**Subject:** 20-06-28 pba to BM Camden - worhouse North facade staircase window level 2

Re: Workhouse AOV – North Façade 2nd Floor Staircase Window

## BEDFORD PASSAGE DEVELOPMENT

### WORKHOUSE (OLIVER HOUSE)

### AOV WINDOW DETAIL

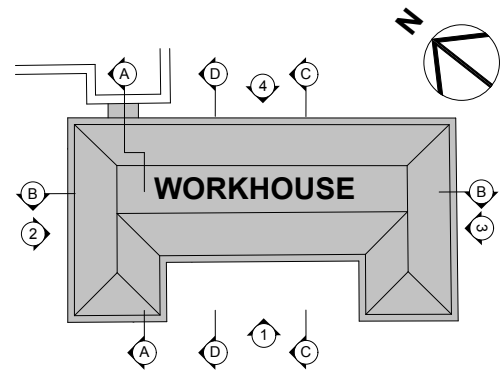
See attached drawing BPD-LDW-WH-ZZ-DR-A-253012 AOV WINDOW DETAIL.pdf

This shows a glass louvered AOV SHEVTEC system that is fully compliant and meets the requirements for EN12101-2. I have attached a link that shows a photograph of the system.

Thanks for sending all this information. It is a shame regarding the louvres, but I think in this instance we need to consider the necessity of the works (which are clearly essential) and then the least harmful way of achieving the required outcome. I agree with you that based on the different options available, the louvres look to be the least harmful way of achieving this. So I support this in principle, but please do send further details once you have them; I'm wondering if the frames could be painted black and whether this would help make them appear less conspicuous.

Drawing Title  
**Listed Building Proposed Elevation 03 & 04**

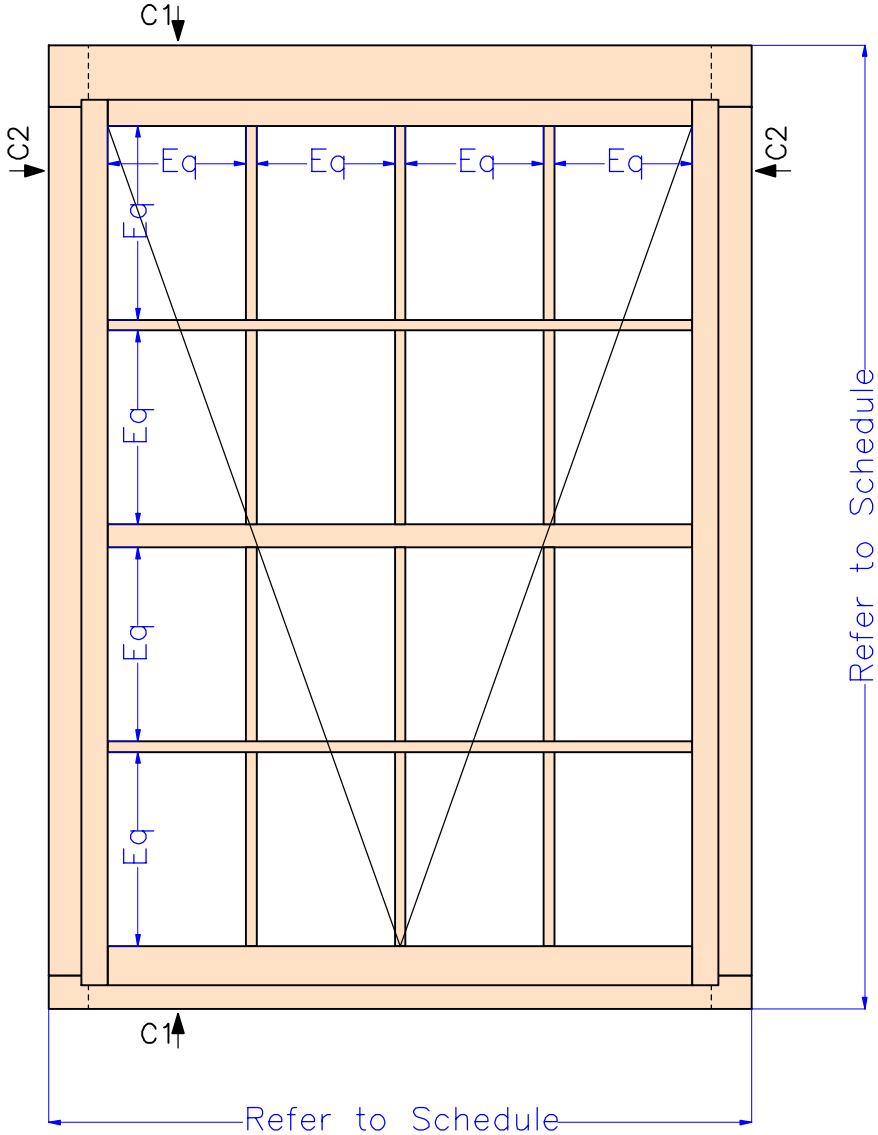
I have also attached a revised elevation called E\_LB\_03-04 Listed Building Proposed Elevation 03 & 04 RevG.pdf. This shows the full North elevation. The glass louvers will also match the louvered glass panels to the new proposed lift tower east of the workhouse. The simplicity of the glass louvers I believe will be less invasive than installing a metal or UPVC window system to this location.

The metal / UPVC windows would be a bottom hung system with a release magnet and chain to open the window in the event of fire & smoke. As these are pre-tested unit we cannot amend or alter the design of the window. These will not be inkeeping with the sash windows. Therefore, we feel the glass louvered system will be more appropriate to the Listed Building.

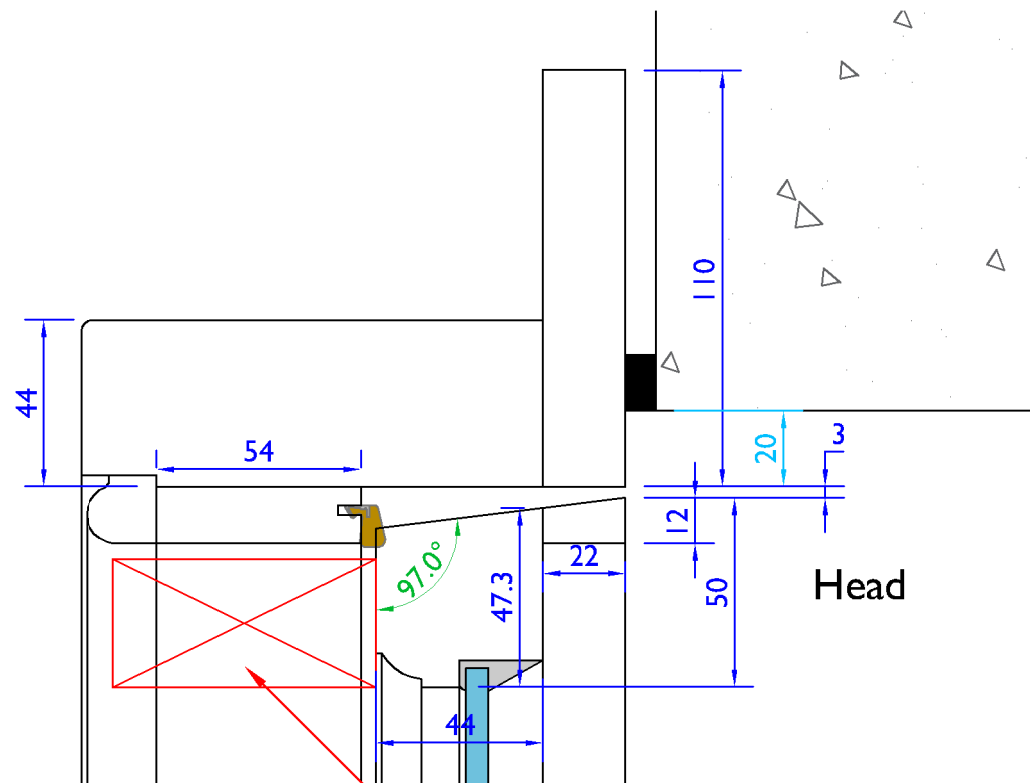
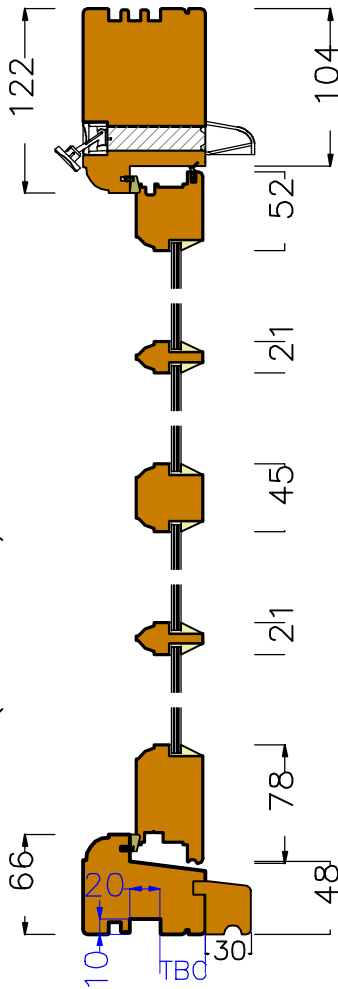
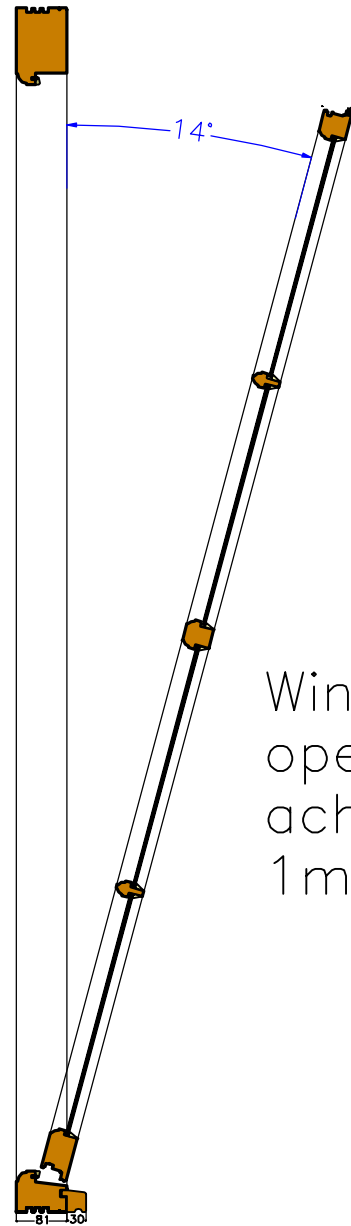
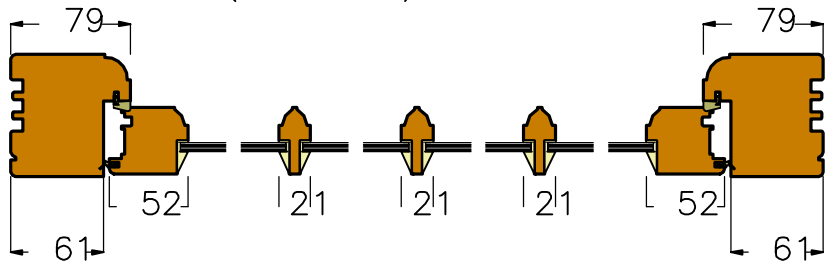
See drawing Option 3A - Workhouse AOV.pdf

The drawing above by the manufacturer was rejected, due to the fact it looked like a casement window and did not resemble the sash windows on the staircase. I subsequently asked the manufacturer to provide a bespoke window that was truly a dummy sash window, except the window opened like a bottom hung basement window. This would then provide adequate smoke ventilation.

| AOV Section detail drawing         |                   |                 |

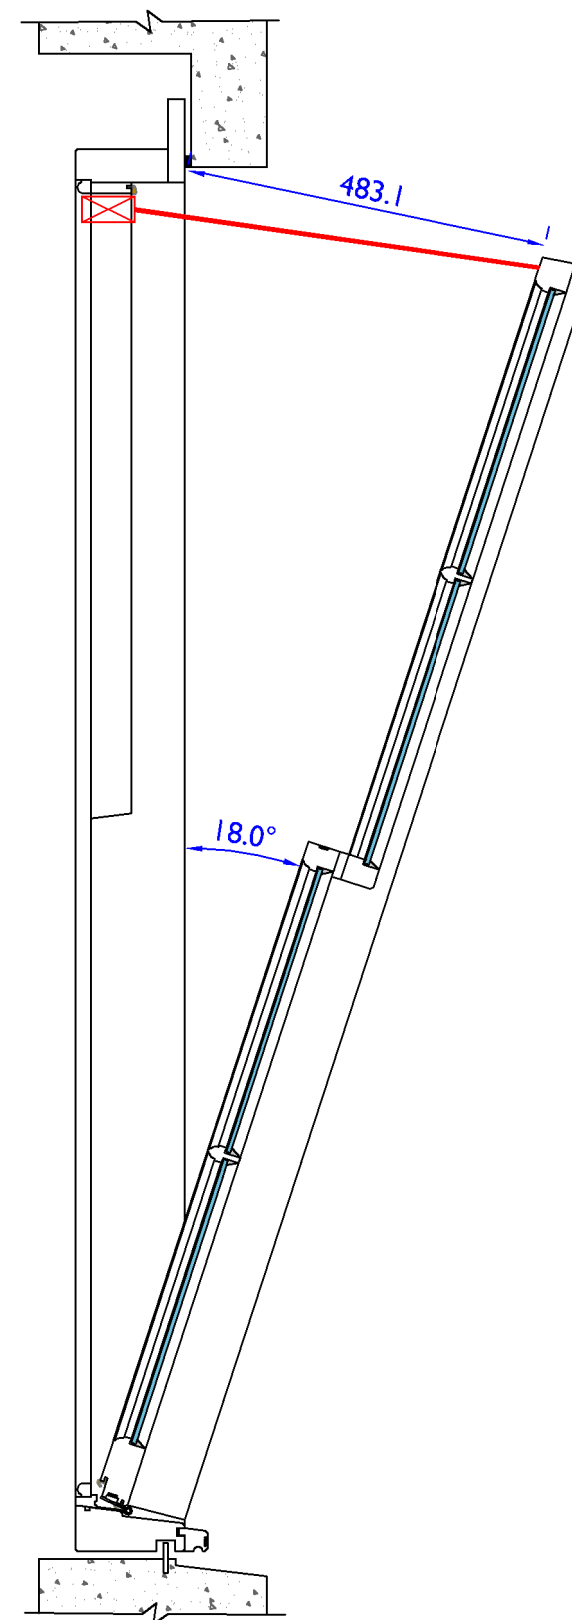
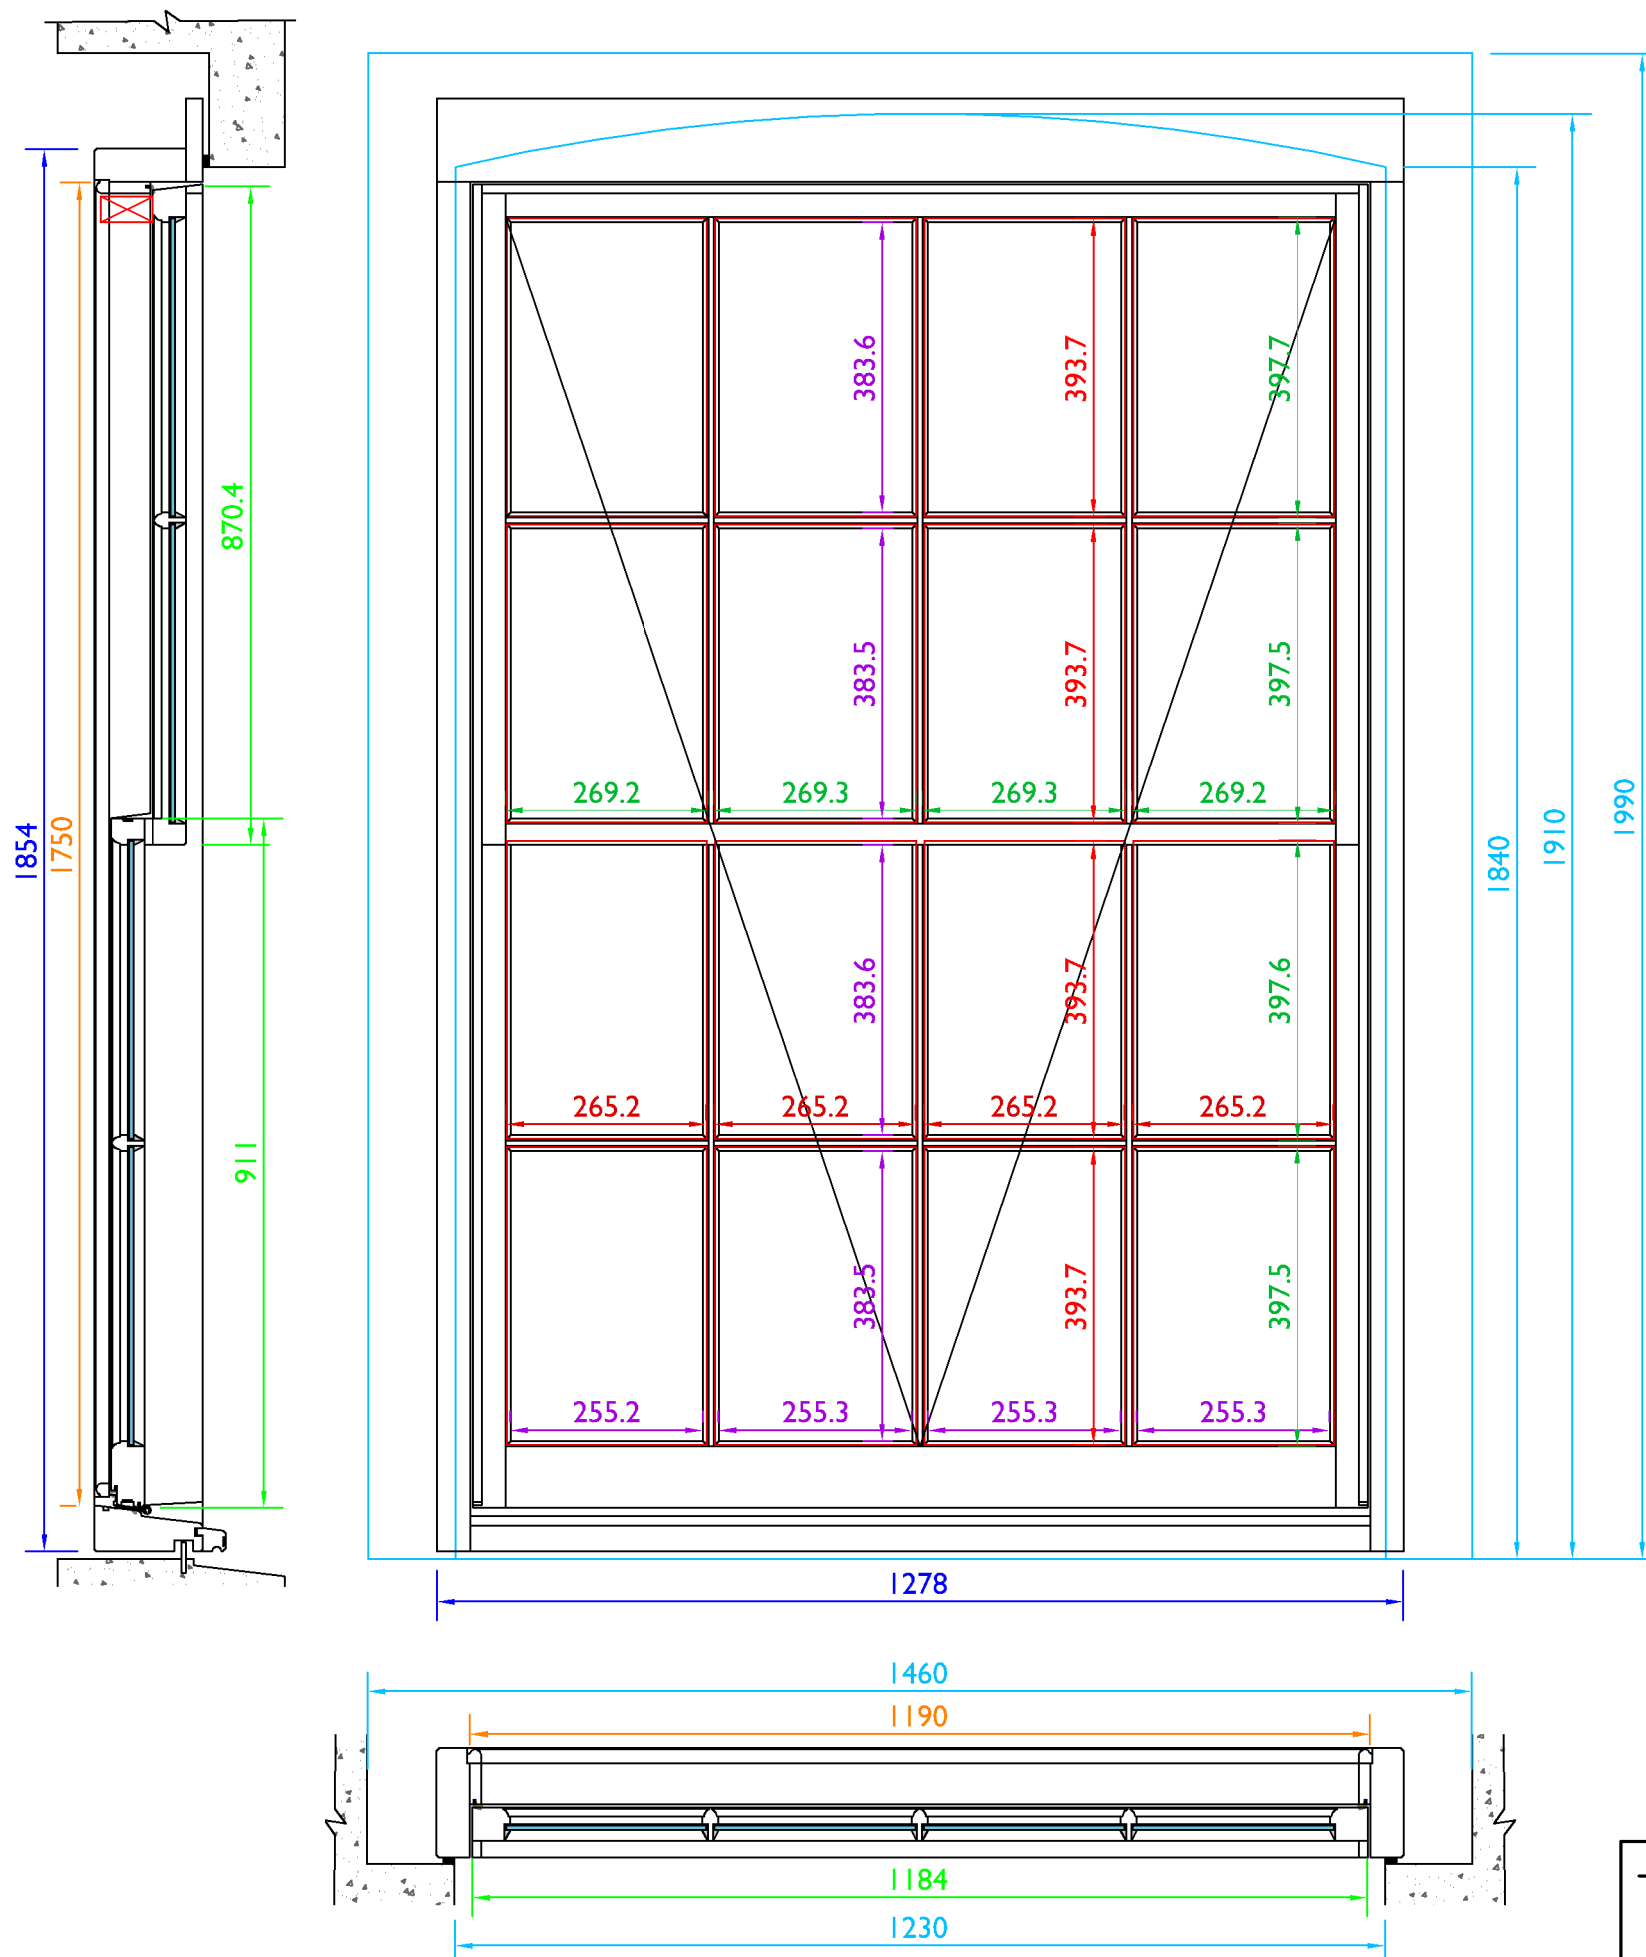
See drawings Option 3B1 - Workhouse AOV.pdf & Option 3B2 - Workhouse AOV.pdf

We agreed with the manufacturer that this was a bespoke solution and asked for the manufacturer to provide the necessary certificates that this would meet BS standards EN12101-2. The manufacturer then informed the design team that due to the bespoke nature of the window, the AOV actuator, that this approach had not been tested together and would not meet the fire requirements.
